Brighton Wastewater Treatment System Upgrades

**ADDENDUM NO. 005**

June 9, 2025

**PARTIAL PROCESS BUILDING BASEMENT FLOOR PLAN**

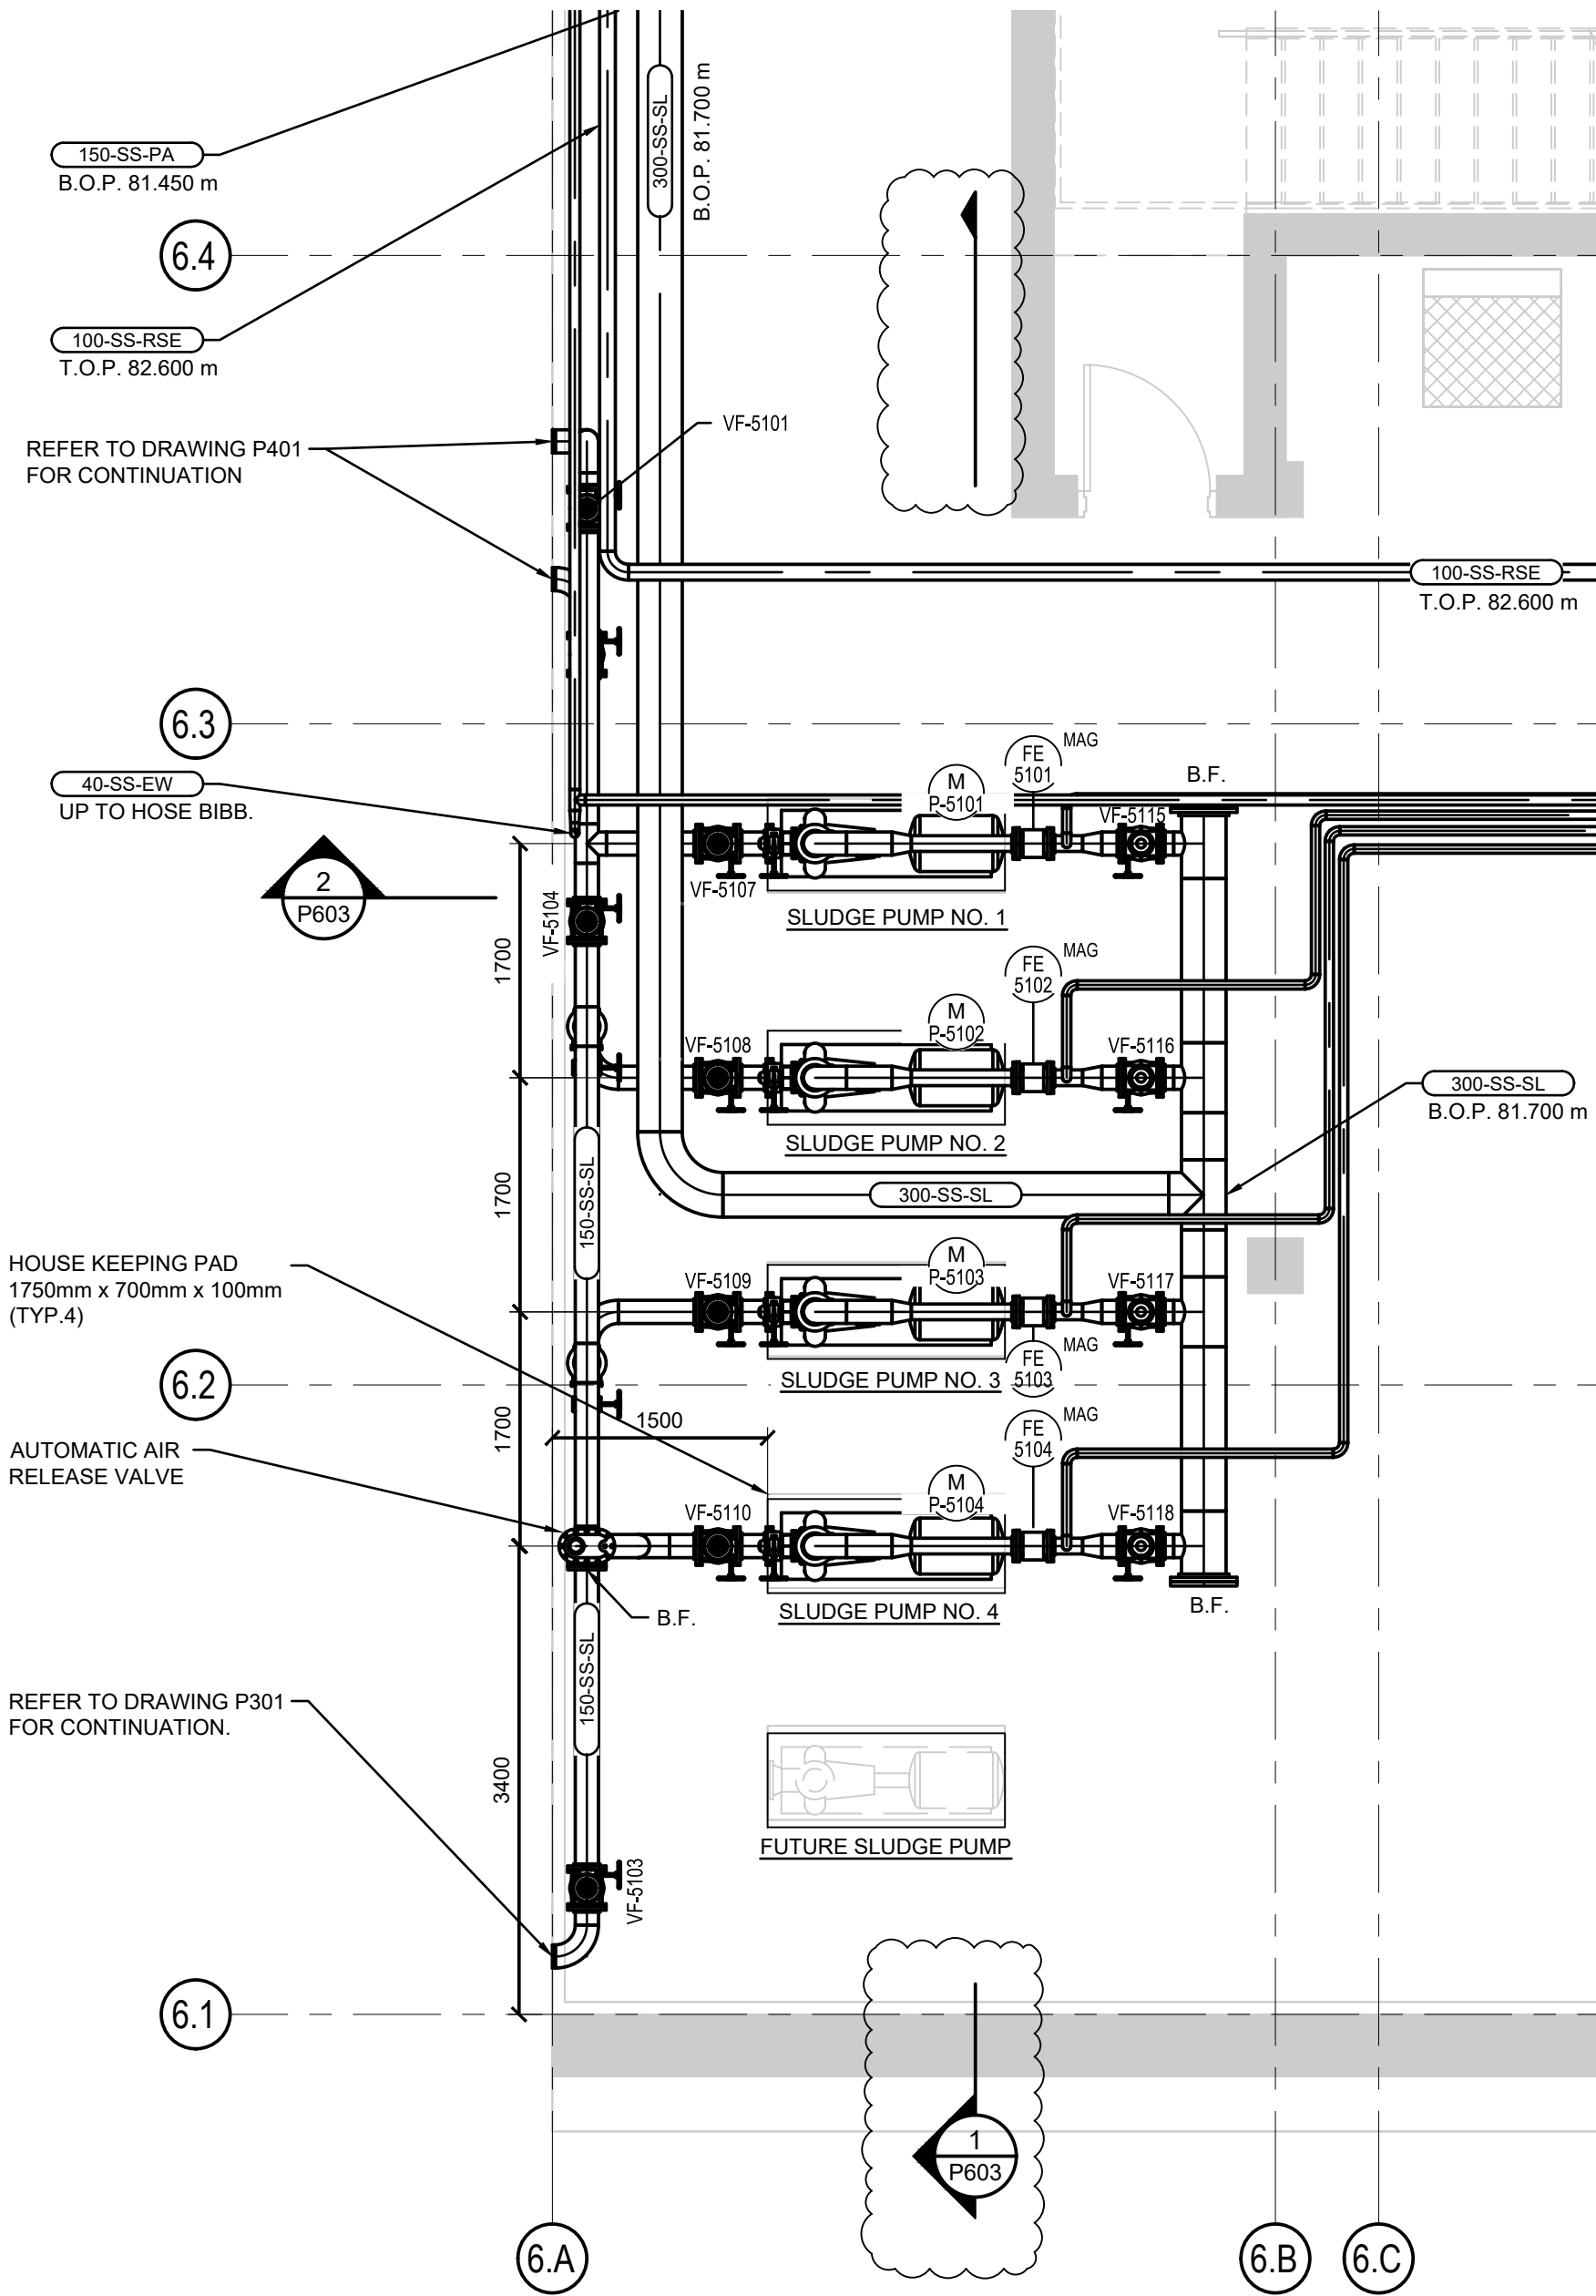
- 19.1 Callout of section 1/P603 provided in attached sketch.

- Item No. 73**     **Drawing P601, Section 1/P603 is not shown.**
- 73.1     Refer to Addendum No. 005, Item No. 19.
- Item No. 74**     **Drawing P701. Provide stainless steel to HDPE connection details, and stainless steel to SDR connection details.**
